Subject:

- 1.) Elevator connection bolt
- 2.) Airbrakes connection bolt (only by install. of Schemp-Hirth-Airbrakes)

- 1.) Elevator-connection bolt
Sailplane Mü 13E "Bergfalke"
" Bergfalke II
" Bergfalke II-55
" Bergfalke III
" Bergfalke IV } all Serialnumbers
- 2.) Airbrake-connection bolts
Sailplane Bergfalke III with mod. 27
(model with Schemp-Hirth-airbrakes)
Sailplane Bergfalke IV all Serialnumbers

Instructions: Instruction 1
Inspect if the connection bolts are affected.
Not affected are (these bolts are already made of "Aircraft steel"):

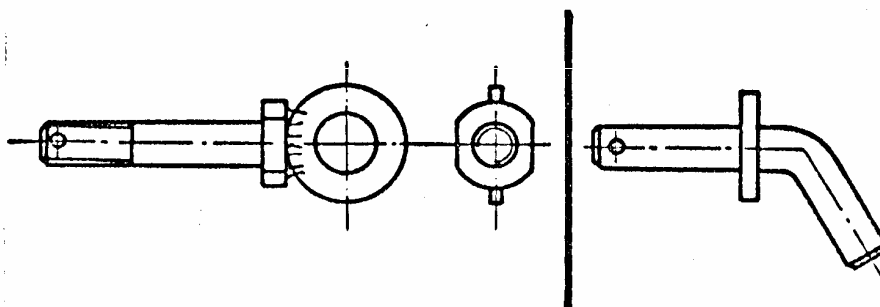
- a) "halfautomatic" elevator connection bolts (the bolt slides in a tube which is welded to the elevator lever).
- b) elevator connection bolts in the following construction

Instruction 3

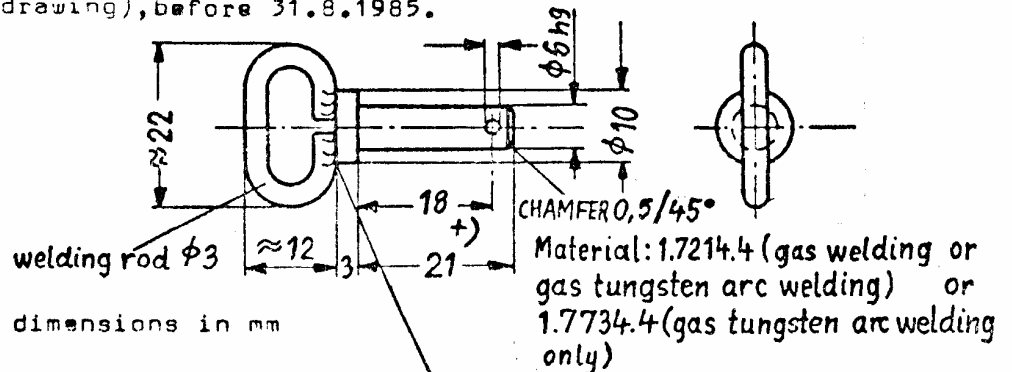
Reason: On some "Bergfalke" Sailplanes (not all), a connection bolt for elevator and airbrakes was installed, made of an eyebolt with a welded handle (made of welding rod) (see sketch)

Under bad circumstances the molecular of the eyebolt (DIN material), can change during the welding of the little handle to the bolt.
There has been a damage to a bolt for the airbrakes.
For the safety, it is necessary to inspect the DIN-bolts for eventual cracks and before 31.8.1985 replace them against bolts made of "Aircraftsteel" (1.7214.4 or 1.7734.4 (see drawing Instruction 3)).

If the connection bolts are not made of "Aircraftsteel", they must be replaced against such of aircraftsteel (see drawing), before 31.8.1985.

here as difference to the eyebolt (from DIN material) no

- +) a certain amount of Bergfalke's are "amateur-build" ^{chamfer}. Therefore there may be differences in the length of the bolts, and they must be fitted to the actual Bergfalke. In any case with the new connection bolts the controls must be checked carefully on function and clearance.
